Report: TAB Report
Function: Test, Adjust, & Balance
Date: 05/29/2025
Completed By: National TAB

PROJECT
05-26-25 CAVA WARWICK, RI

Project Summary

Issue Name : 1. RTUs On Incorrect Curbs

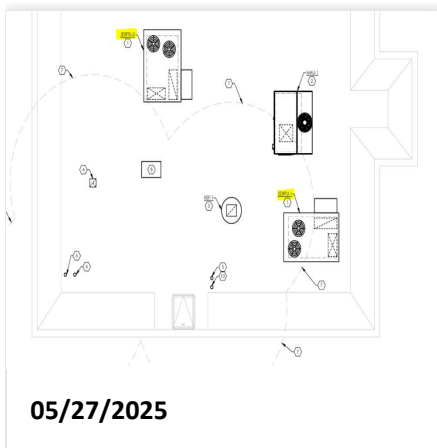
Description : The "48FCD09" unit is serving the Dining Area and the "48FCDN12" unit is serving the Kitchen. Per the mechanical plans, the larger unit is supposed to serve the Dining Area. To achieve proper cooling of the space, these units will need to be swapped.

- **05/27/2025 National TAB - Stephen Tassinaro**
 - Currently both units will be balanced to 400CFM/Ton respectively. This will not match the designs shown on the mechanical plans since there is now 4000CFM in the kitchen instead of 3400CFM. And 3400CFM in the dining room, instead of the original 4000CFM. All diffusers will be proportionally balanced.

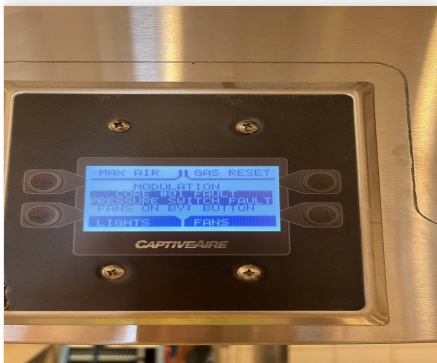
Issue Name : Grease Duct Not Secured to Curb
Description : Duct top plate flanges to the edges of the curb, but it is not secured. This allows for movement of the grease duct and grease will accumulate.
Created By : National TAB **Assigned To :** National TAB - Will Turnbough
Status : Open
Priority : Medium **Asset Tag :**
Originated Date : 05/29/2025 - Stephen Tassinaro - National TAB

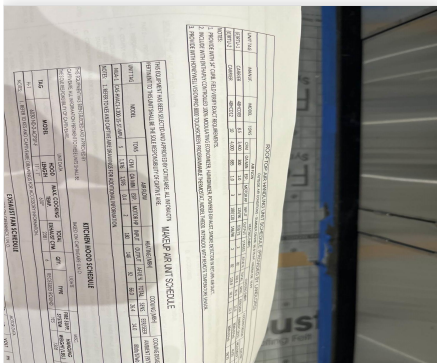
Issue Name : Humidity Sensors
Description : There are no humidity sensors installed in the space. They are noted on M701, but locations are not shown. Recommend discussing with EOR to determine necessity and/or locations of these sensors.
Created By : National TAB **Assigned To :** National TAB - Will Turnbough
Status : Open
Priority : InfoOnly **Asset Tag :**
Originated Date : 05/29/2025 - Stephen Tassinaro - National TAB
